STATE OF NORTH CAROLINA  
DEPARTMENT OF TRANSPORTATION

Subject: **Revision to Permit Application for an Individual Section 404 and Section 401 Water Quality Certification** for the widening of NC 49 from East of NC 73 to East of SR 2630 (Cline Road) in Cabarrus County. Federal Aid Project No. NHS-0049(26), Division 10, TIP No. R-2533CC.

Reference: Individual Permit Application dated September 7, 2010

Permit Drawing  
Sheet 36 of 51

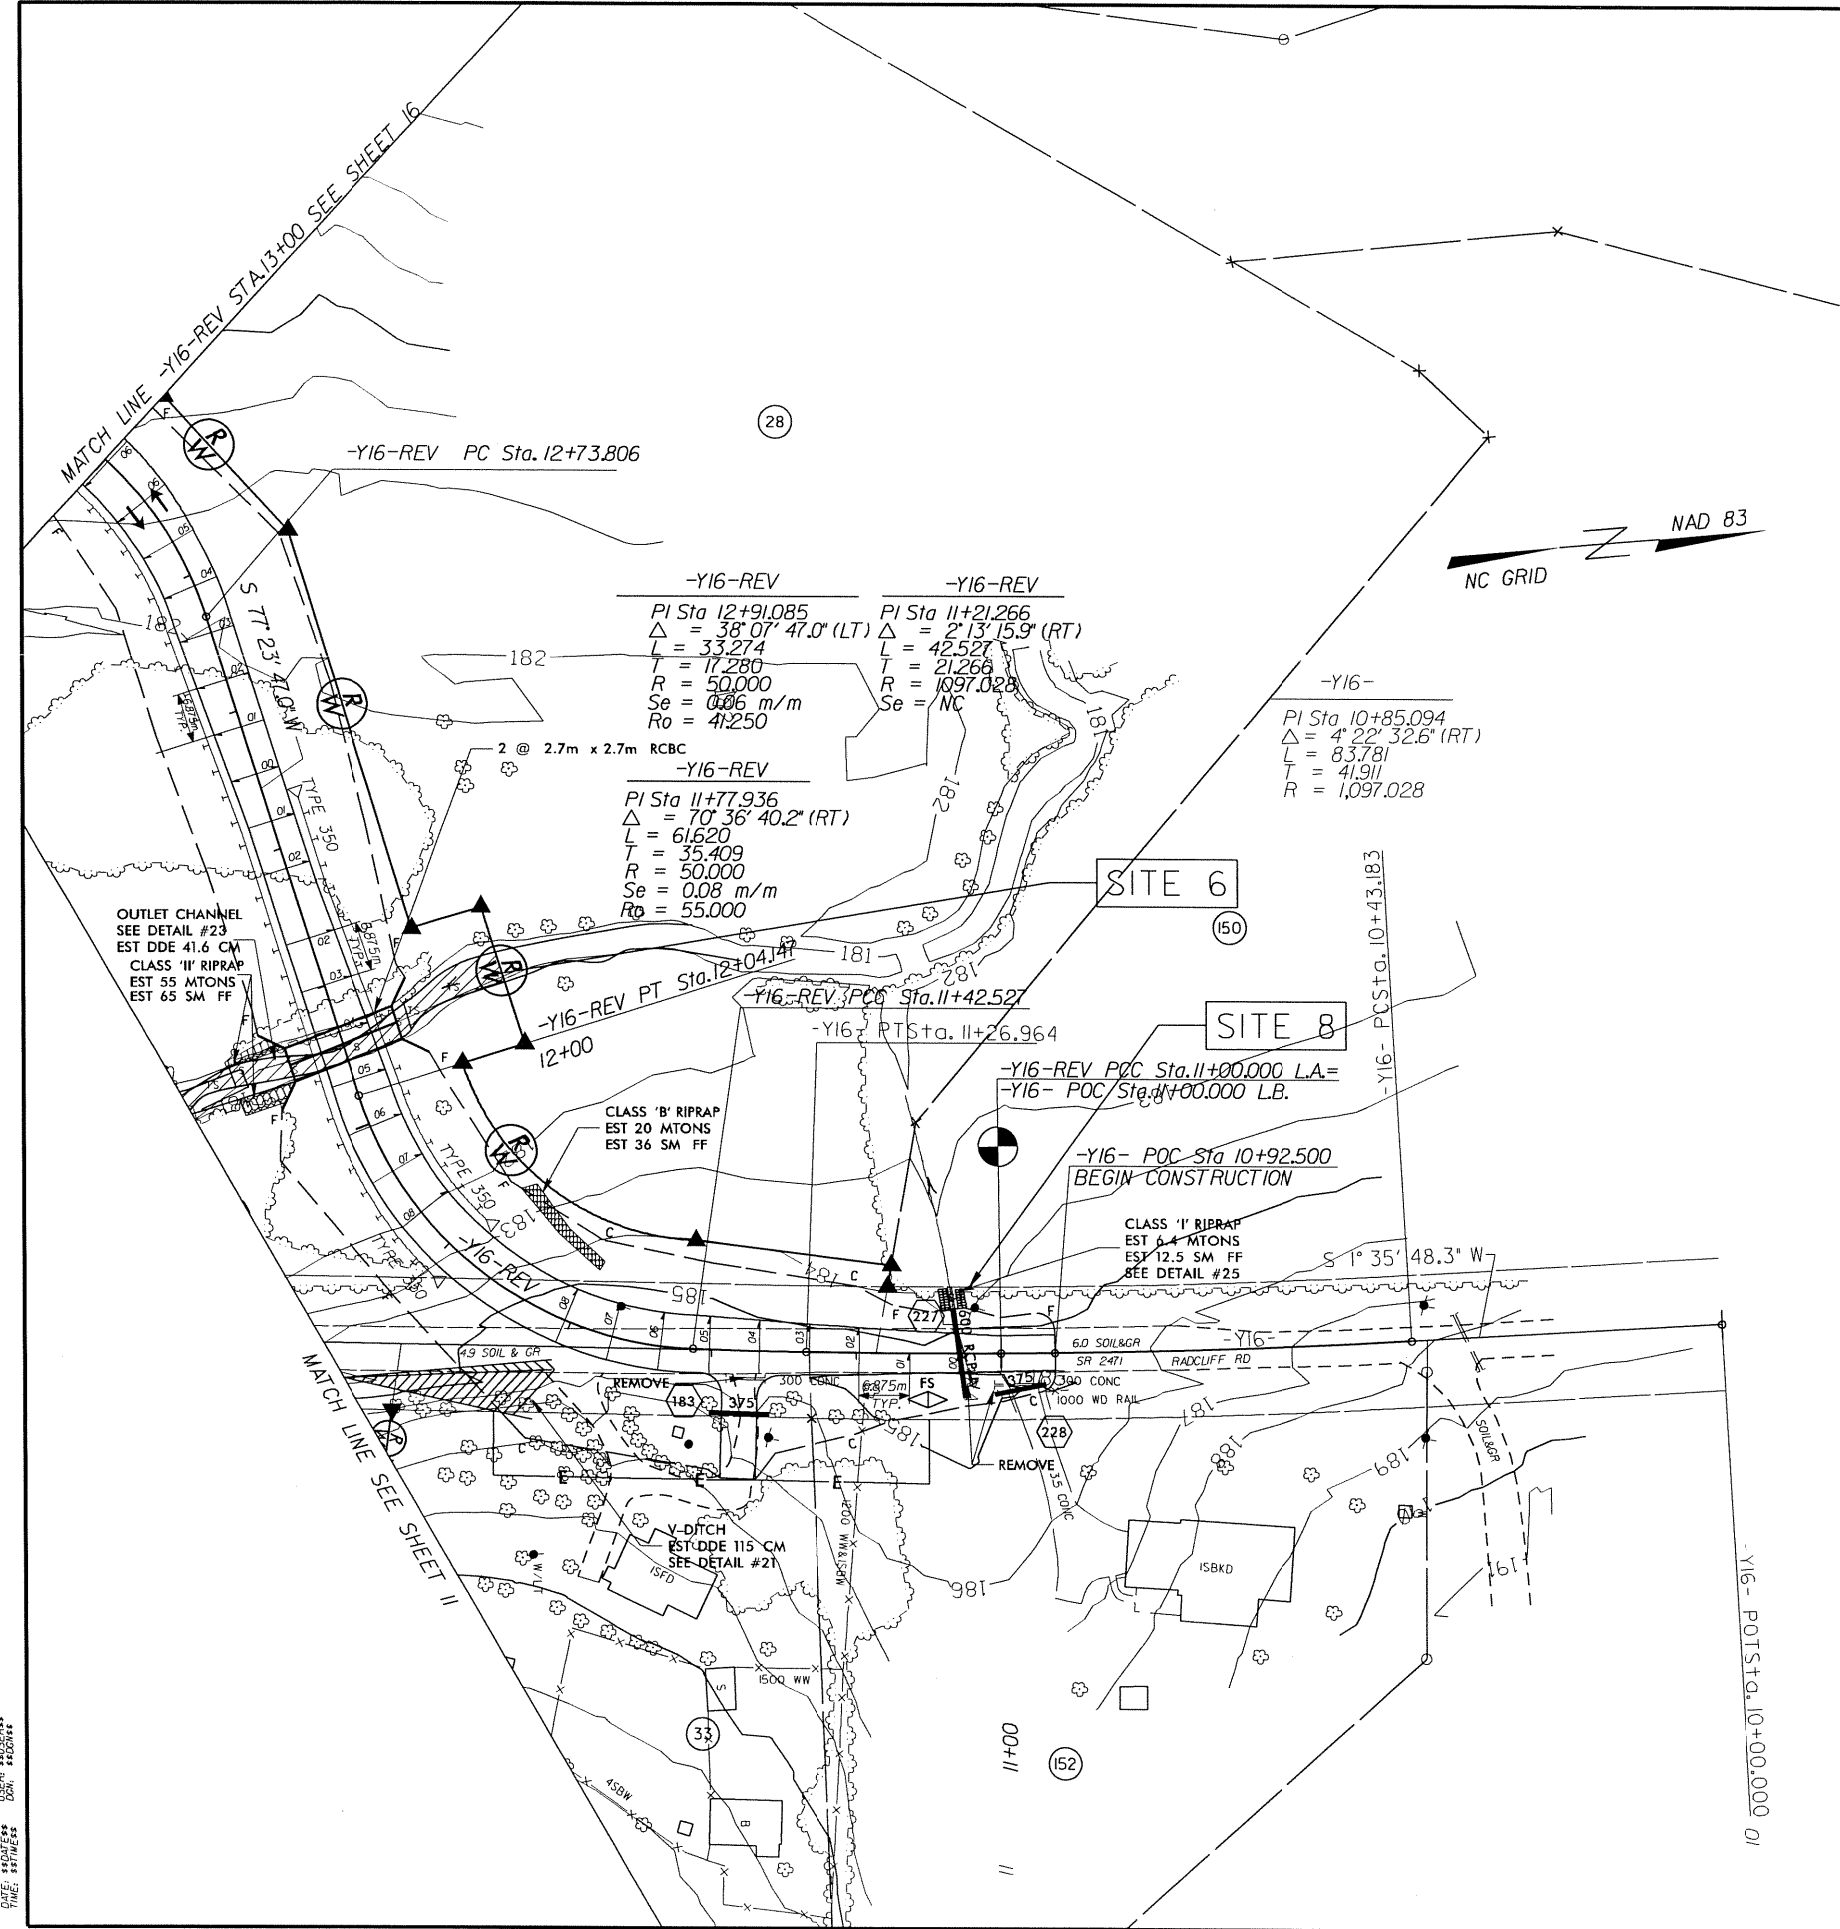
- Permit Site 5 – It appears that this stream will be relocated to a culvert (upper reach) and then to a ditch (lower reach). If the upper reach will be piped, how is the stream going to get into the pipe? The plans show the stream (depicted as impacted) with the culvert parallel to it, but I don’t see a spring box or other mechanism to get the stream into the pipe. Please clarify.
